DATE: December 11, 2019

SUBJECT: ADDENDUM #3 TO THE BIDDING DOCUMENTS FOR:  
**BID GROUP #8**  
**MASTER FACILITY PLAN IMPLEMENTATION**  
**COMMUNITY HIGH SCHOOL DISTRICT 99**  
**1436 NORFOLK STREET**  
**DOWNERS GROVE, IL 60516**

This addendum forms a part of the Bidding Contract Documents, dated November 20, 2019. Bidders must acknowledge receipt of this Addendum in the space provided on the Bid Form. Drawing revisions clouded and tagged throughout with delta 39.

1 FIRST FLOOR LIGHTING PLAN AREA F  
SCALE: 1/8" = 1'-0"

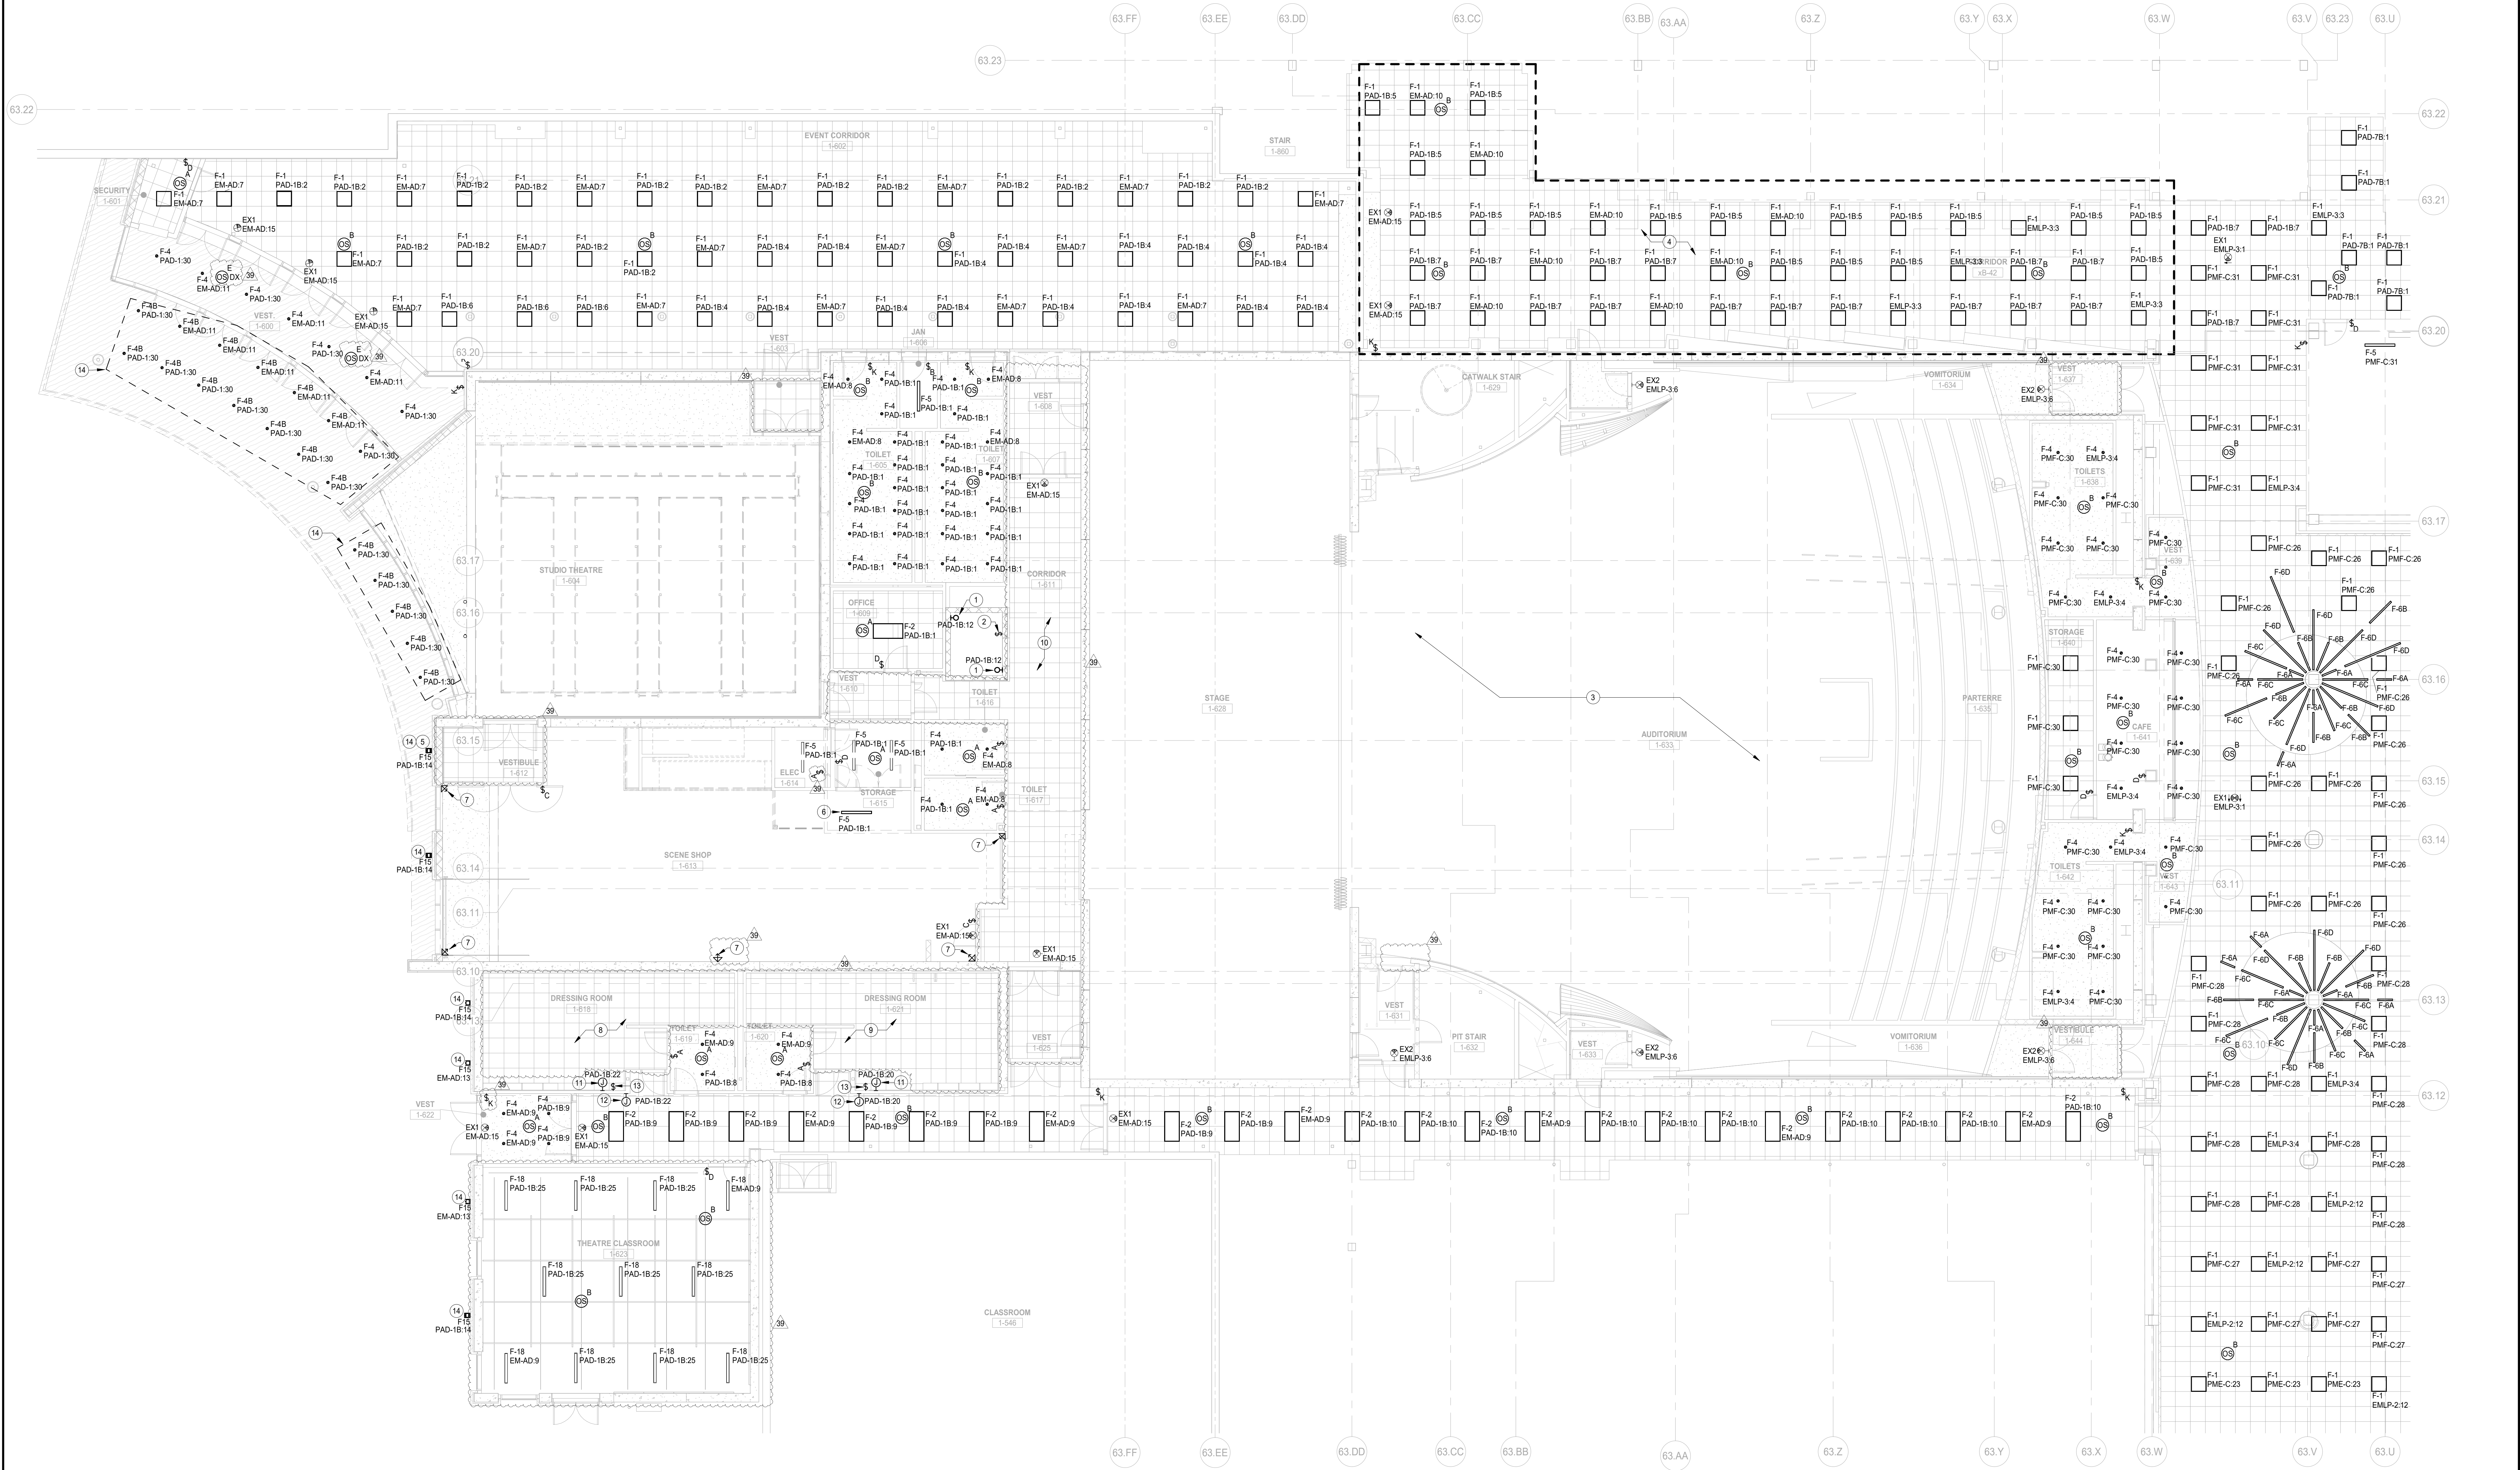
15. Sheet E3.01F-1c FIRST FLOOR LIGHTING PLAN AREA F (**Full size sheet reissued**)
- a. Update (2) ceiling mounted occupancy sensors to be day light occupancy sensors in vest. 1-600.

- h. Remove exit sign from outside of vest. 1-631.
16. Sheet E3.02B-1c SECOND FLOOR LIGHTING PLAN AREA B (**Full size sheet reissued**)
- a. Added one occupancy sensor and key switch to corridor 2-316.

**TR1.13**

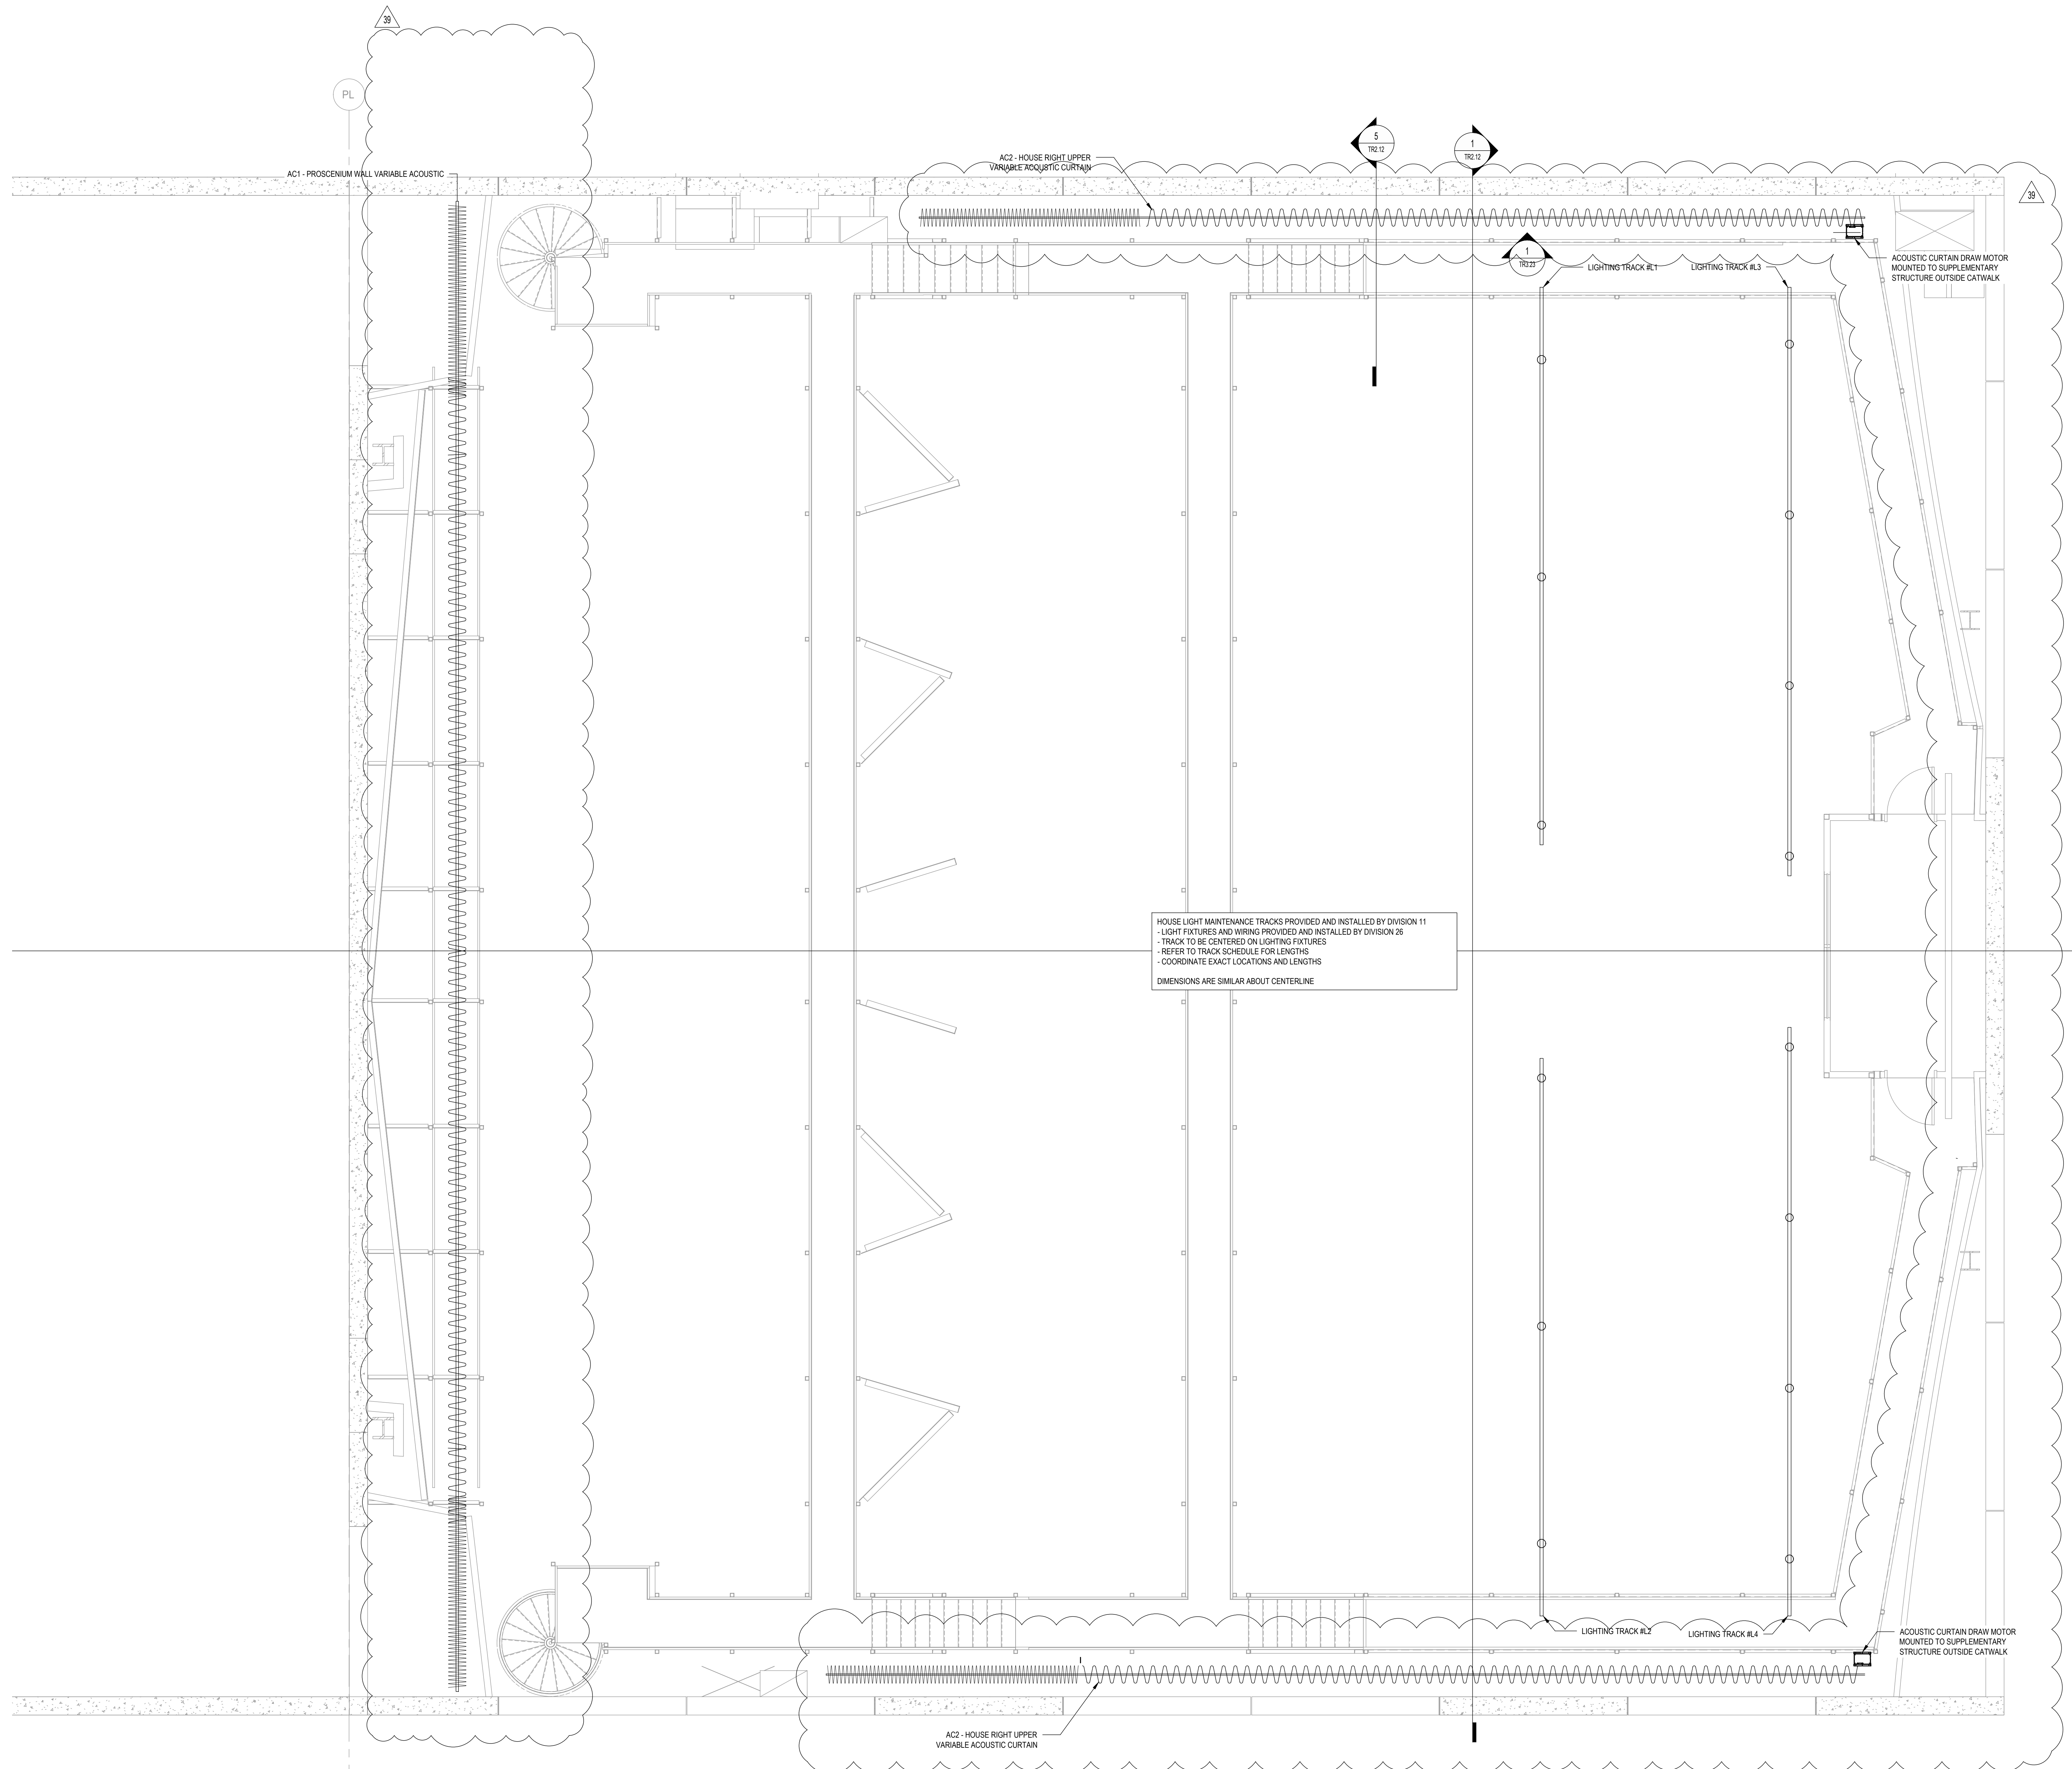
1. Sheet TE6.12 THEATRE LIGHTING & DISTRIBUTION PROSCENIUM THEATRE SCHEDULES (**Full size sheet issued**)
- a. Corrected load sums in lighting device schedule.
2. Sheet TR1.13 THEATRE RIGGING PROSCENIUM THEATRE PLANS (**Full size sheet issued**)
- a. Relocation of Proscenium Wall Acoustic Curtain.

- b. Relocation of rear wall acoustic curtains to side walls.
- 3. Sheet TR2.11 THEATRE RIGGING PROSCENIUM THEATRE SECTION **(Full size sheet issued)**
  - a. Relocation of Proscenium Wall Acoustic Curtain.

**TR3.22**

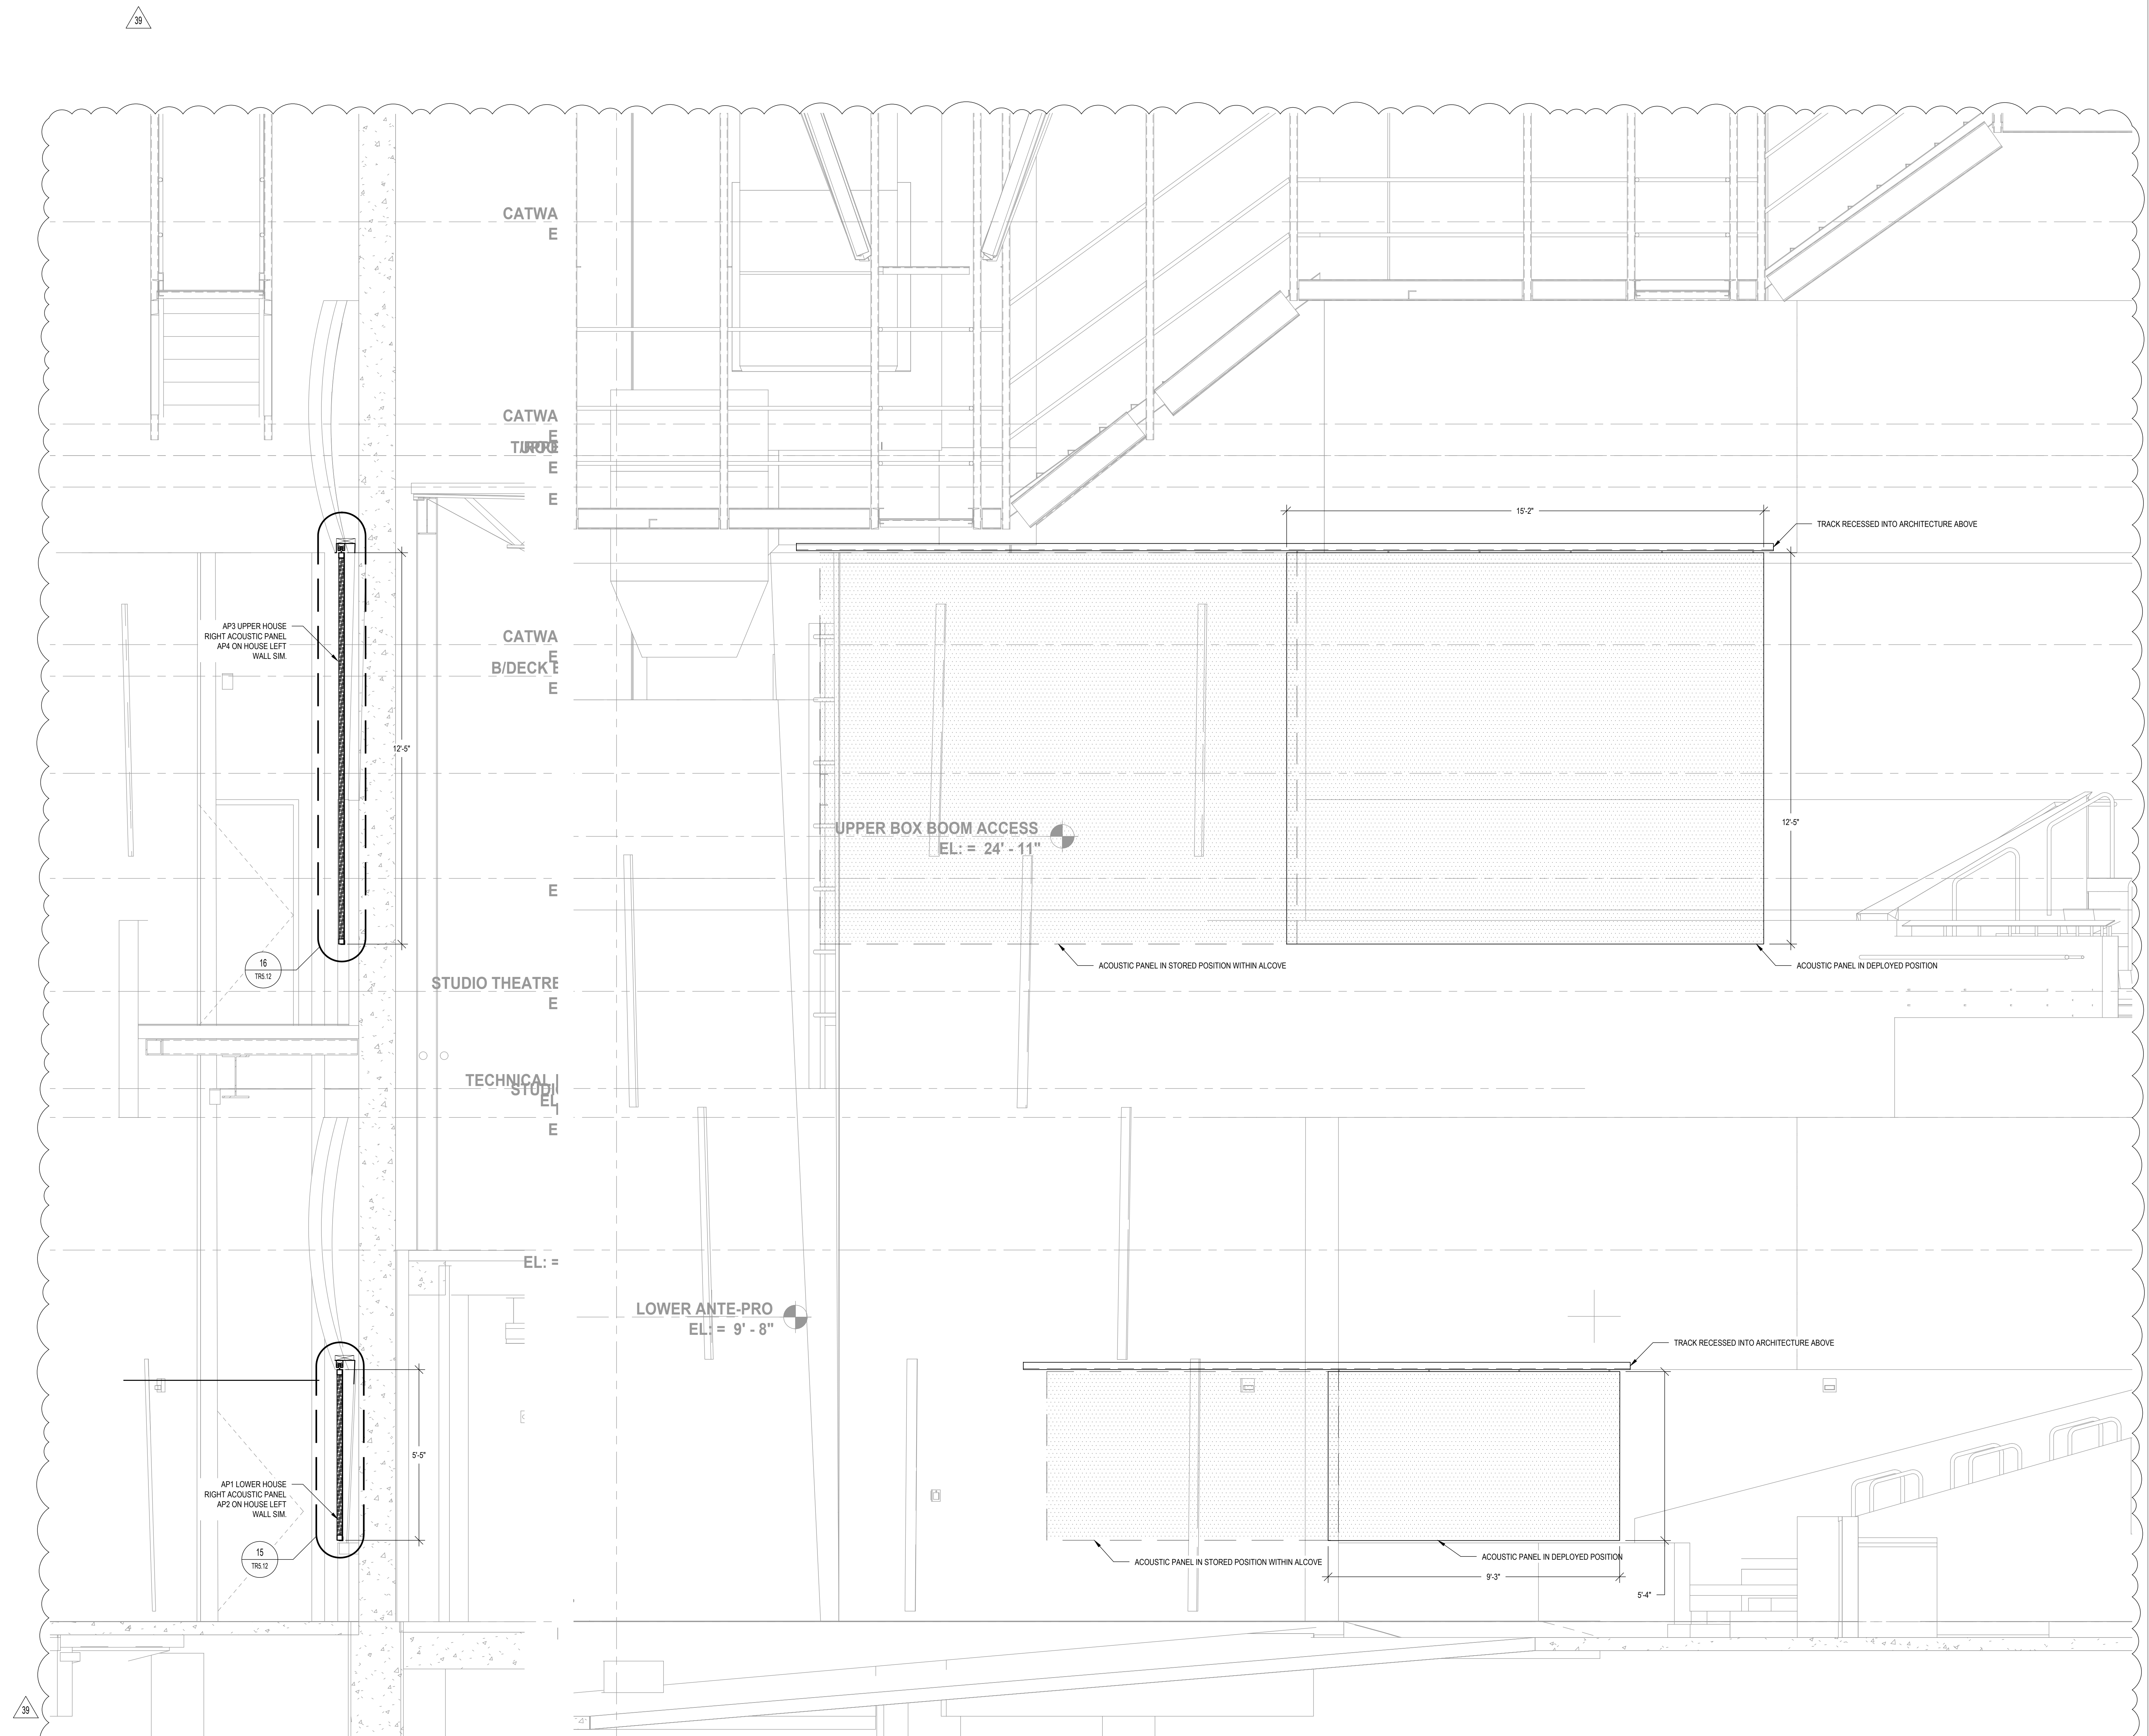
- 5. Sheet TR3.22 THEATRE RIGGING PROSCENIUM THEATRE ELEVATION **(Full size sheet issued)**
  - a. Adjusted size of side wall acoustic panels.
- 6. Sheet TR3.23 THEATRE RIGGING PROSCENIUM THEATRE ELEVATION **(Full size sheet issued)**
